1.0 OVERVIEW AND PURPOSE OF THE FINAL EIR

This document, together with the Draft Environmental Impact Report (Draft EIR) constitutes the Final Environmental Impact Report (Final EIR) for the proposed Sequoia Hospital Campus/Precise Plan in Redwood City, California.

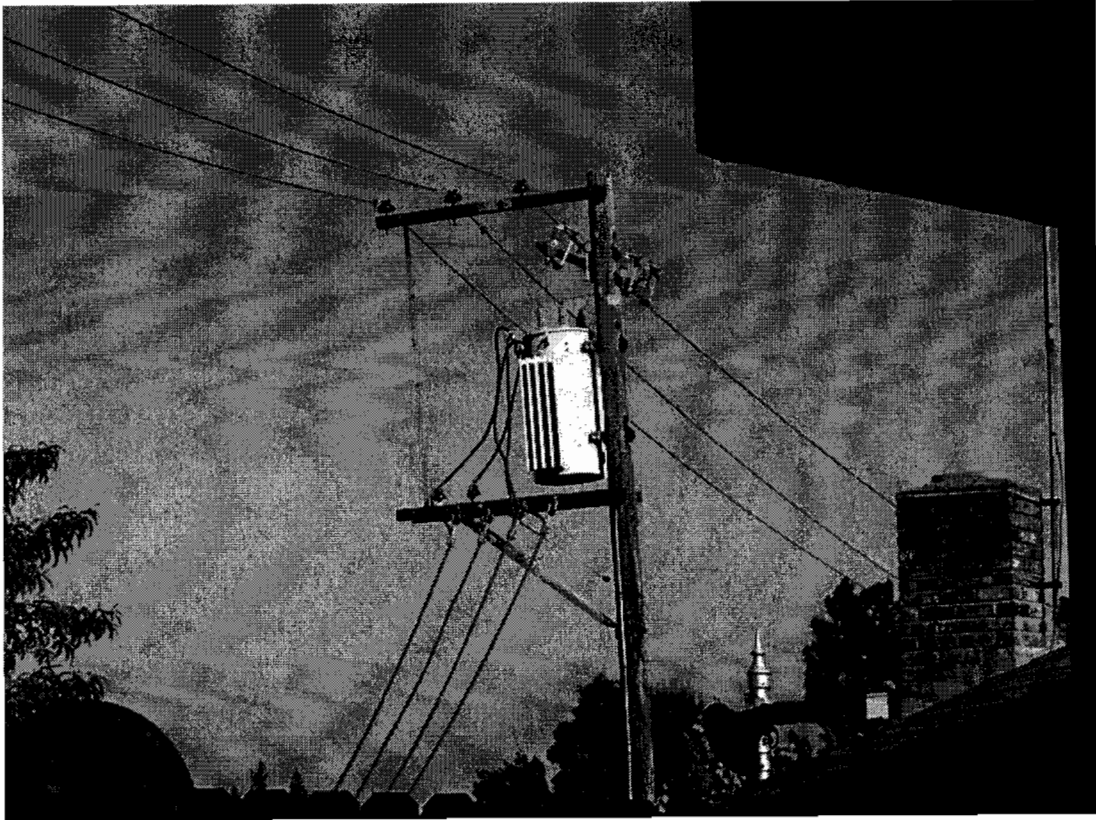
- 9) Neither the EIR nor Draft Precise Plan address the removal of the non-working electrical transformer and a communication cable currently located behind the skilled nursing facility and the effect it will have on the surrounding area. These issues should be considered and included in the report too. (Attachments A and B) **3-9**

The project applicant has indicated that the pole currently provides electrical services for the Skilled Nursing Facility and will likely serve as the power drop for the proposed Medical Office Building. Modifications to the electrical service (i.e., the pole mounted transformer) may be made; however, all options have not been determined at this stage of design.

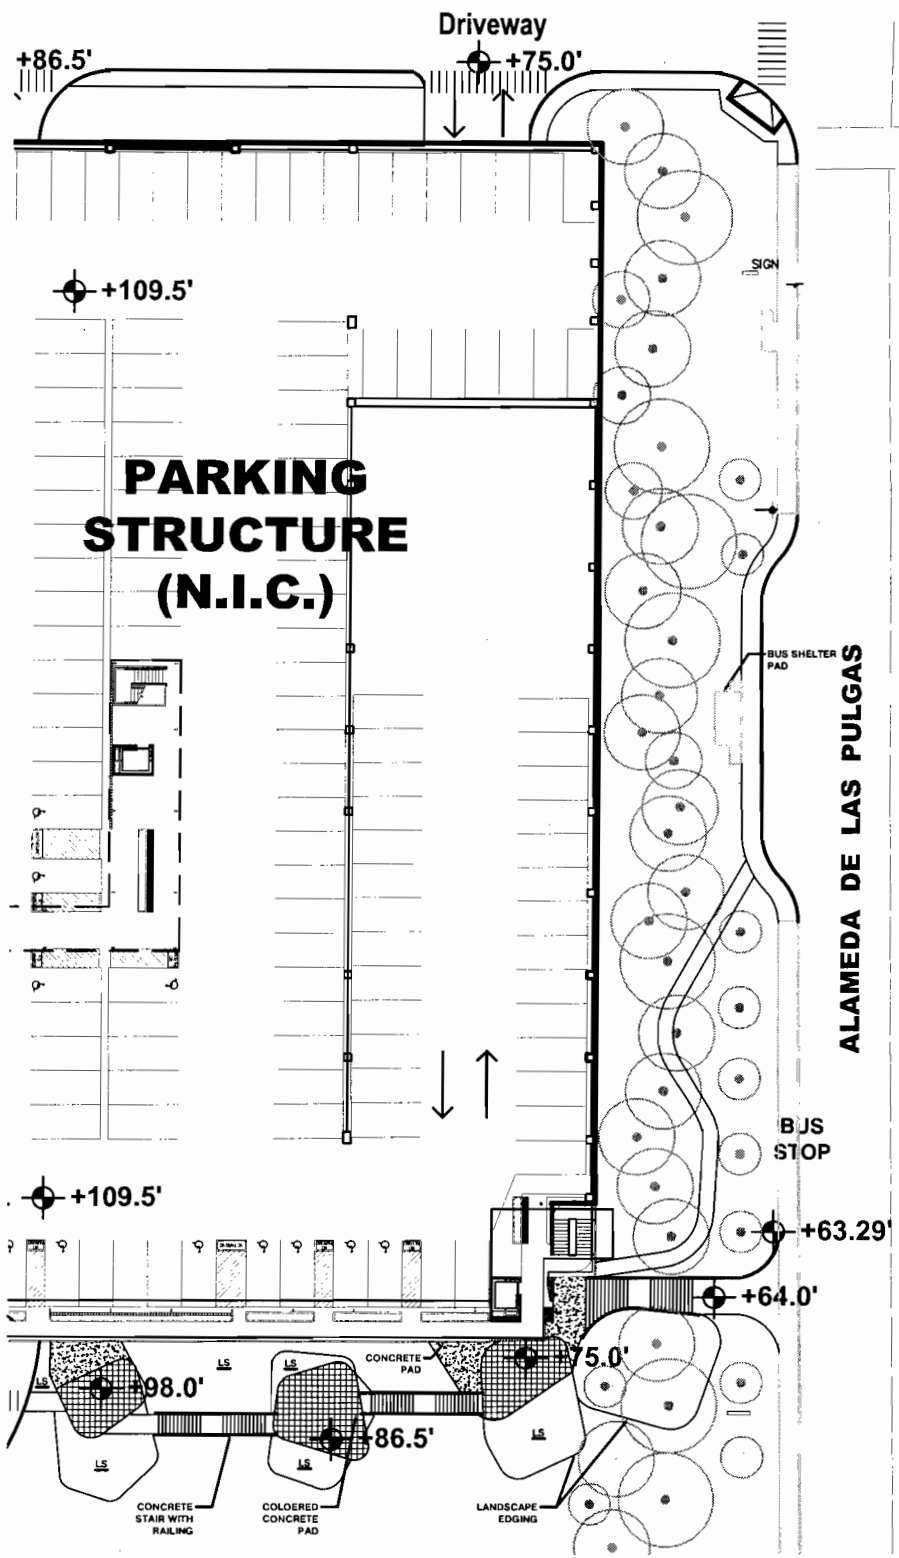
Known areas of controversy in the summary are the potential increase in traffic and spillover into resident areas needs to be better addressed. Figure 4.2-5, bus stop improvements, the driveway into the new parking structure shows it in and out, but the site plan shows an island in the loop road, so that no one can make a left turn into the first driveway into the parking garage, is that correct?

Figure 4.2-5 suggests that it is possible to make a left turn into the parking structure from the loop road, creating a potential queuing problem onto Alameda. However, I believe that the site plan shows a median on the loop road in this area, preventing the possibility of a left turn. This should be clarified. | **5.9-6**

Figure 4.2-5 Bus Stop Improvements has been revised to show the planned median in the northern project driveway (see **Section 6.0 Revisions to the Text of the Draft EIR** on page 63 of this document).

Figure 4.2-5 Bus Stop Improvements has been revised to show the planned median in the northern project driveway (see **Section 6.0 Revisions to the Text of the Draft EIR** on page 63 of this document).

- Page 60 Figure 4.2-5; **replace** Figure 4.2-5 Bus Stop Improvements as shown on the following page.

FIGURE 4.2-6 (REVISED)

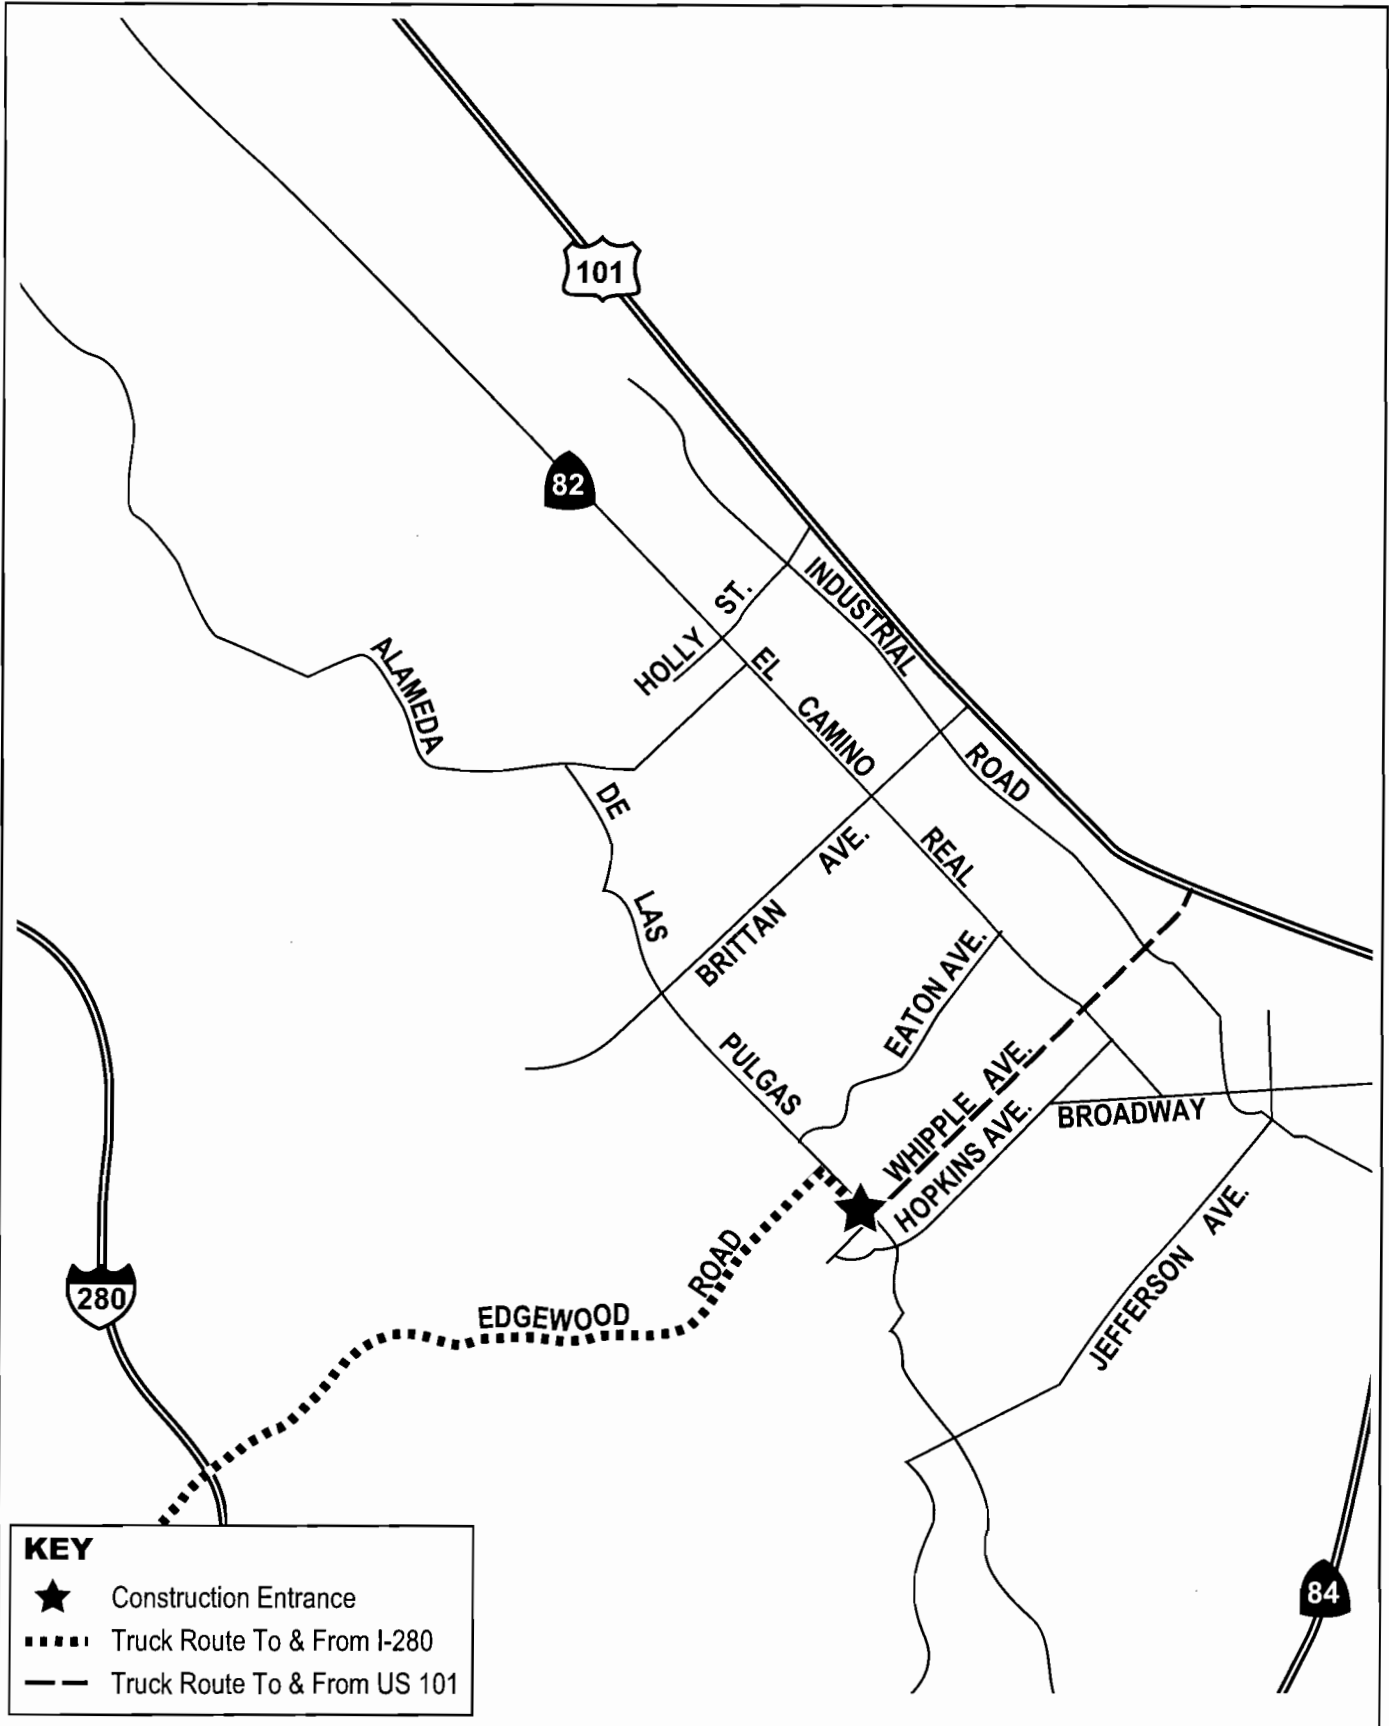
As the comment period expires for the Sequoia Hospital EIR, it is my impression that San Carlos city officials have yet to weigh in on the prospect of utilizing Brittan Avenue as the route for soil removal.

Dramatic traffic increases, both during and subsequent to project completion, are inevitable for the Whipple Corridor. In the interest of fairness, however, we are relying on project planners to provide traffic volume equity throughout east-west corridors, both in Redwood City and in San Carlos, a partner in the Hospital District.

Based upon further review, the proposed route for trucks over 3,000 tons to and from U.S. 101 has been modified. They would follow the most direct route to and from U.S. 101 and the site via Whipple Avenue. The text and graphics in the Draft EIR have been revised to reflect this change (see **Section 6.0 Revisions to the Text of the Draft EIR**). These revisions do not change any of the conclusions in the Draft EIR regarding the significance of construction transportation impacts.

Large trucks traveling to and from U.S. 101 would use Whipple Avenue ~~Brittan Avenue (in the City of San Carlos)~~ to access Alameda de las Pulgas and the project site (refer to revised Figure 4.2-6).

Page 64 Figure 4.2-6; **replace** Figure 4.2-6 Truck Routes as shown on the following pages.
